***Pinnacle Risk Management response to the queries from the Department of Planning and Environment dated 20/2/17 re the Preliminary Hazard Analysis for the proposed distillery at Shoalhaven Starches, Bomaderry.***

***Dean Shewring***

***21/2/17***

***Diagram showing the heat flux at various distances from 2 m<sup>2</sup> fires with various fuel mixtures of ethanol and gasoline. That is, gasoline has the higher SEP for small diameter fires.***

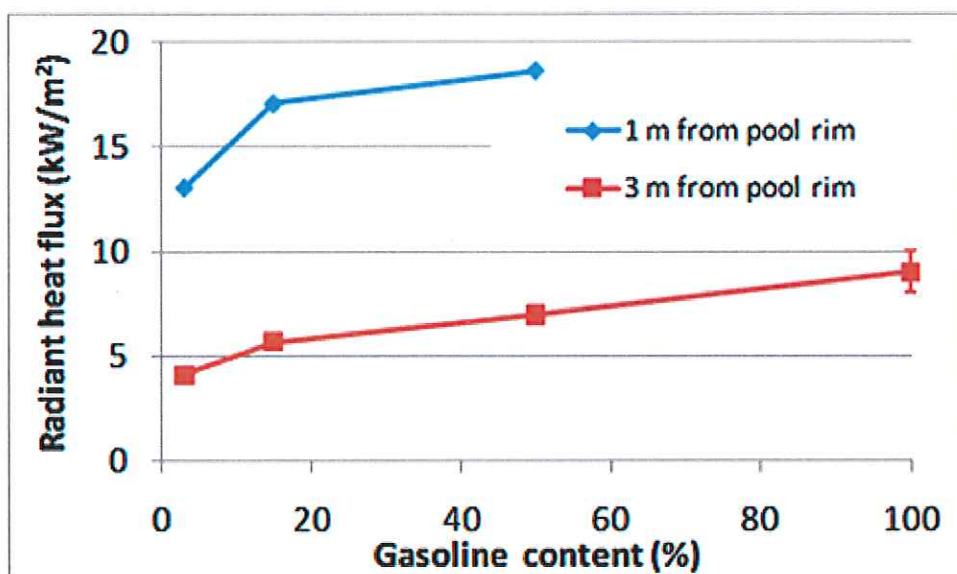
1. The PHA assumes SEP of 50kW/m<sup>2</sup> for large pool fires (pool diameter >25 m) and 60 kW/m<sup>2</sup> for smaller fires. Taking into account that the ethanol fires are luminous, the SEPs used in the analysis appears to be optimistic. Please provide the basis for the assumed SEPs.

PRM Comment: The SEP data is based on the results of the ETANKFIRE research, published data and previous studies for ethanol fires, e.g. SHERPA Consulting for Vopak at Port Botany. Data from the ETANKFIRE study for small and large diameter fires are shown below.

For large diameter pool fires, the test results show that the heat exposure can be as much as 3 times higher for ethanol than for gasoline. Using the Mudan equation for gasoline, the SEP is 20 kW/m<sup>2</sup> for large diameter fires. Therefore, the SEP for ethanol

is taken to be  $50 \text{ kW/m}^2$ , i.e. an average of 2.5 times the gasoline SEP. This is very similar to the modelling work by SHERPA Consulting for Vopak at Port Botany.

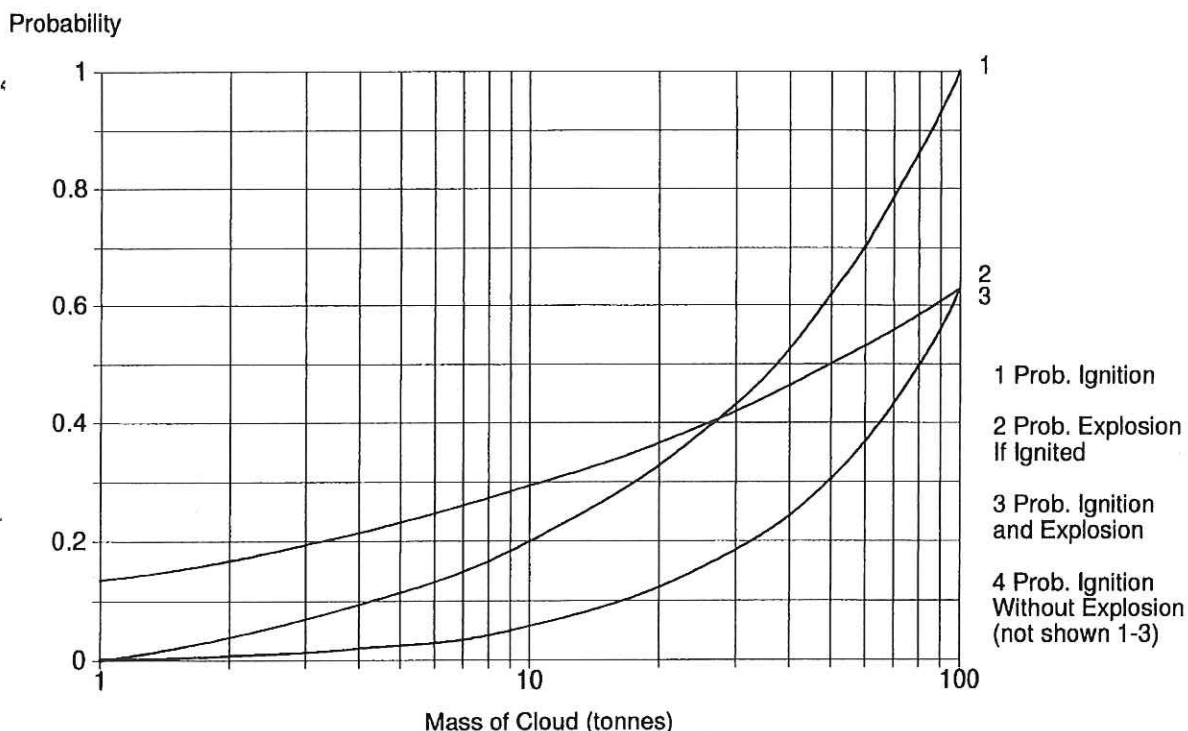
7. The failure frequencies presented in Table 8 of the PHA appear to be optimistic. For example, the frequency suggested in TNO purple book is with 1 order of magnitude higher than the frequencies used in the PHA. Using the TNO frequency, the overall frequency for the flash fire/explosion event would be around 3.5E-06. Please provide a justification on the used data or otherwise ensure that the analysis err on conservative side by using conservative failure frequencies

PRM Comment: The data used in Table 8 has been used for approximately 20 years and has been accepted each time by the Department of Planning. It is based on research and is likely to be conservative now that improved design, construction and safety management systems are in place.

Please note that CCPS, Layer of Protection Analysis, Simplified Process Risk Assessment, 2001, quote a pressure vessel failure range of  $1 \times 10^{-7}/\text{yr}$  to  $1 \times 10^{-5}/\text{yr}$  with  $1 \times 10^{-6}/\text{yr}$  as a mean value.
